CITY OF ALBUQUERQUE

RE: Juan Tabo Hills Estates Revised Grading Plan Engineer's Stamp Date: 8/30/18 Hydrology File- M21D018; DRB# 1005278

> Re: Juan Tabo Hills Estates Revised Grading Plan Hydrology File-M21D018; DRB 1005278

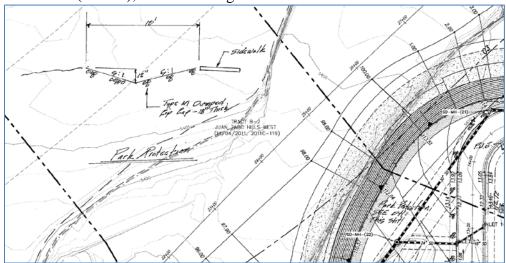
- 1. Provide self-ponding areas in the interspace (park) between the AMAFCA access road and the public road, or drain away from bank protection per AMAFCA direction. The contours and spot elevations should reflect the access road as sloping at 2% away from the top of shotcrete and back into the park area. If used, the ponding areas should be sized for the 10-day, 100-yr volume with supporting calculations provided. If this grading will be part of the landscaping plan, then the landscaping plan need to be included when resubmitting.
 - 2. Provide rip-rap armoring at the outside bend of Sandia Sunset. If water surcharges out of the NMDOT inlet upstream near MH-47, flows will travel overland down Sandia Sunset and will likely jump the curb at this bend. Mark hand drew a detail and location of this on the previous submittal (sheet 5), but it did not get carried over this time:

- 3. A standard detail for the AMAFCA access and maintenance road has been added to the Details sheet. The detail indicates that there is a 2% cross slope away from the bank protection on the maintenance road. The runoff from this area will go into depression areas. The details of which will be worked out in the overall landscape plan being prepared by others. The ponding areas can be worked out in conjunction with the landscape plan.
